Subject: Dresden Station Units 2 and 3
Quad Cities Station Units 1 and 2
Request for Schedule Changes for
Human Engineering Discrepancy (HED)
Corrective Actions
NRC Docket Nos. 50-237/249 and 50-254/265

Commonwealth Edison Company
Quad Cities and Dresden Stations
Human Factors Engineering
Corrective Action Schedule Change Request
December 20, 1988

INDEX NO.: 0162

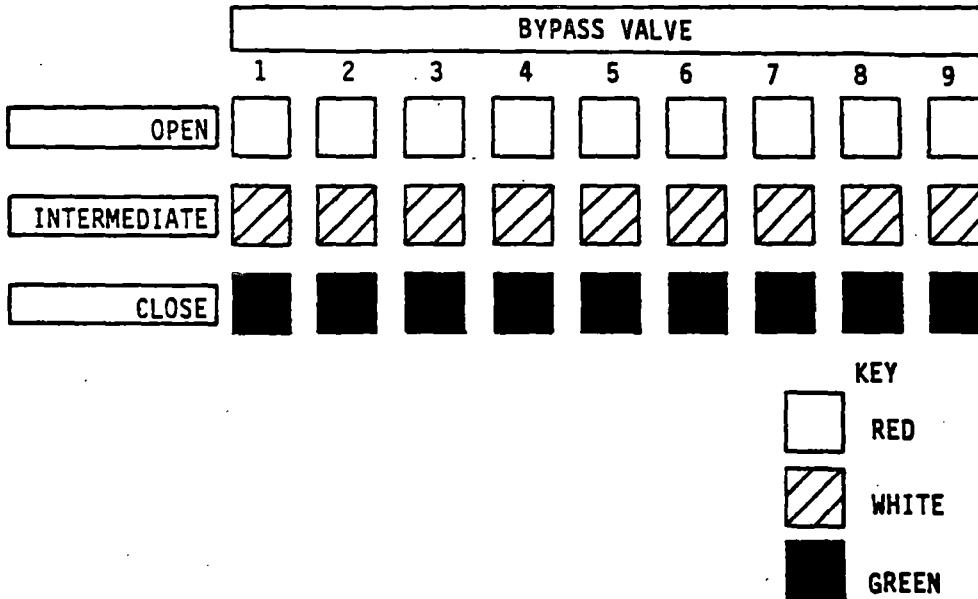
FINDING:

All temporary labels will be replaced with permanent labeling. Matrix labeling will be added to the bypass valve matrix of lights on 90X-7 to adequately identify the meaning of each light.

INDEX NO.: 0173

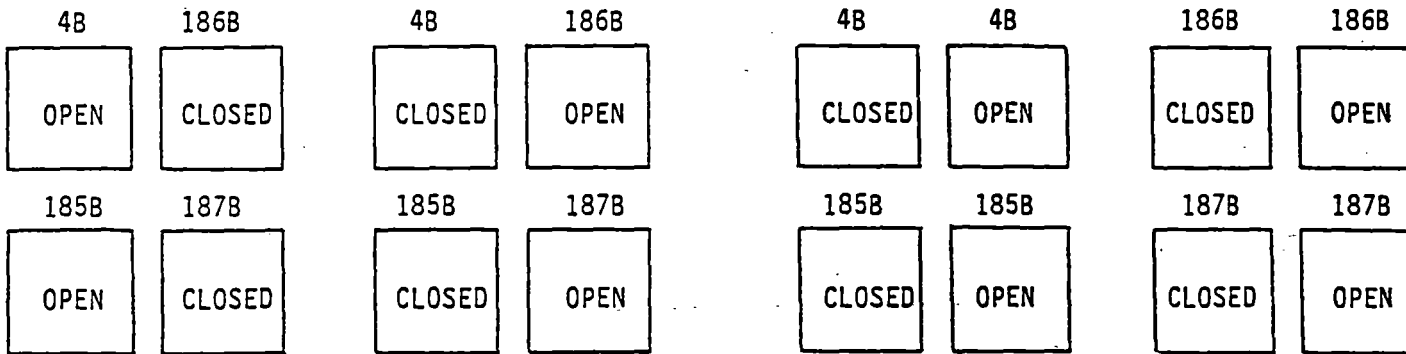
FINDING:

PROPOSED MODIFICATION

INDEX NO.: 0162

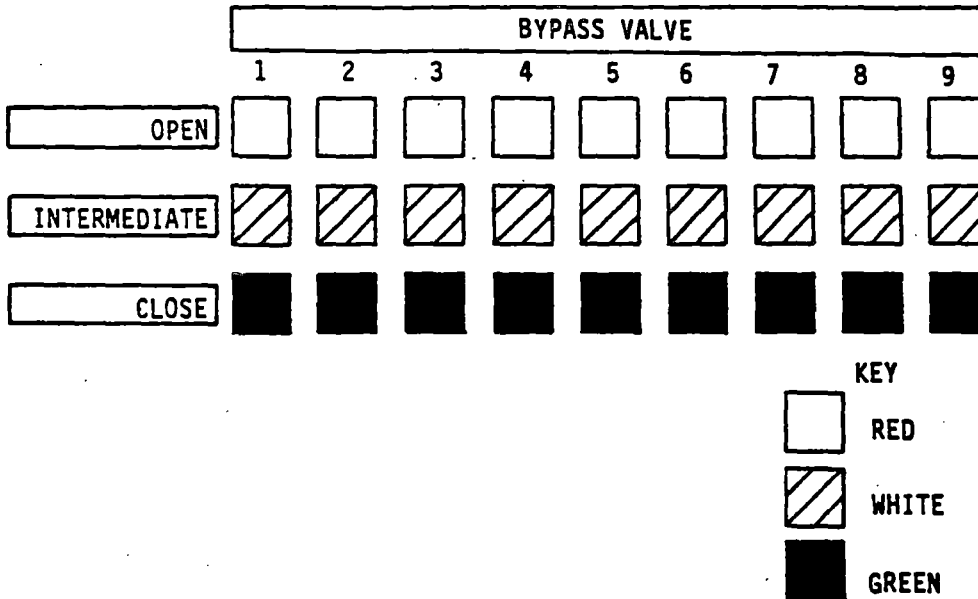
FINDING:

INDEX NO.: 0173

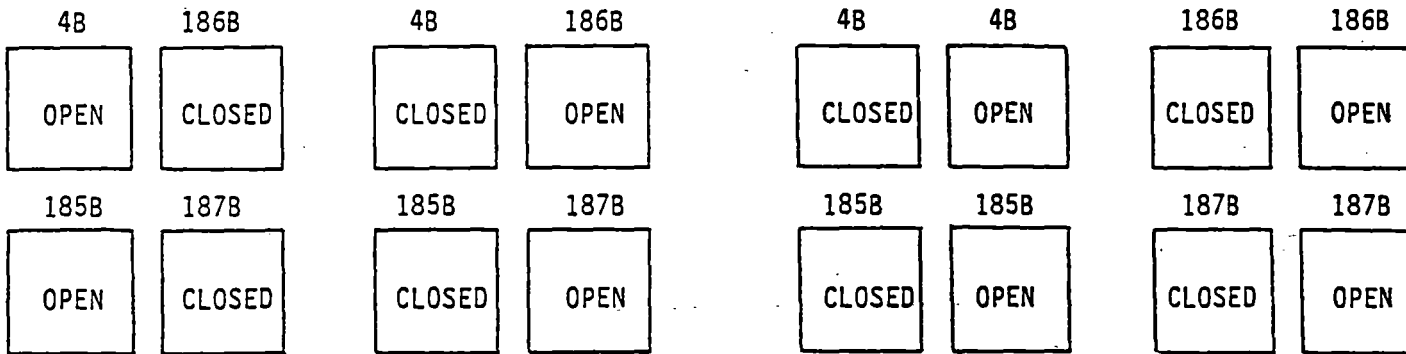
FINDING:
